Township of Lawrence  
**ENGINEERING DEPARTMENT**

SUBJECT: Bulk Variance Application No. ZB-3/23  
**Dr. Pankaj Mohan**, 3870 Princeton Pike  
Tax Map Pages 51.06 & 51.08, Block 5101, Lot 32.02

**Re: Dr. Pankaj Mohan – ZB-3/23  
Block 5101, Lot 32.02 – 3870 Princeton Pike  
Bulk Variance Relief  
EP-2 Environmental Protection 2 District**

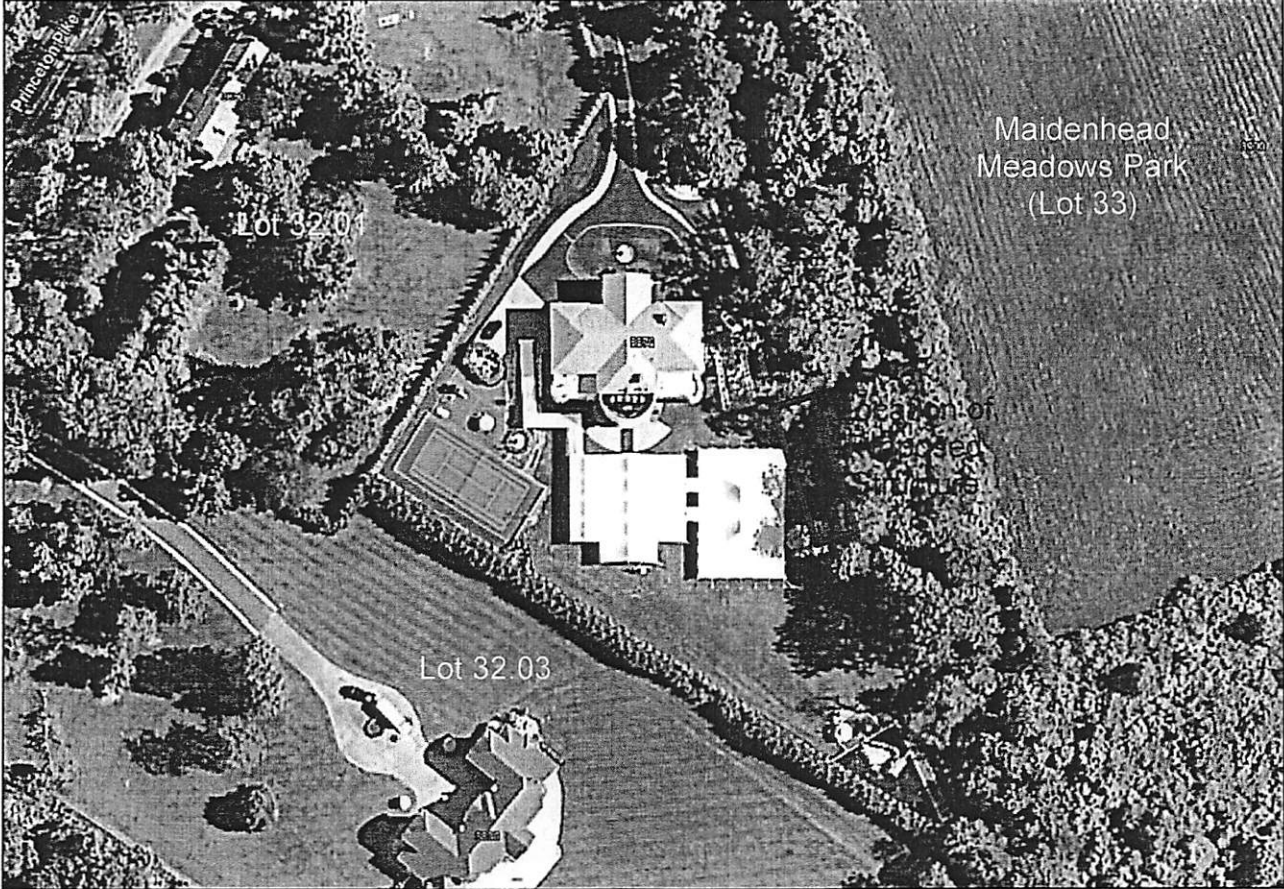
dwelling, synthetic turf patios and seating areas, a 32'x90' sport court and a small pond. Much of the perimeter of the rear half of the property is lined with arborvitae of various sizes. Surrounding land uses include single family dwellings to the south and west and Township-owned open space to the east that is part of Maidenhead Meadows Park. The aerial photo below shows the existing single-family dwelling and location of the proposed accessory pool structure. We note the tents depicted in the aerial are no longer on the property.
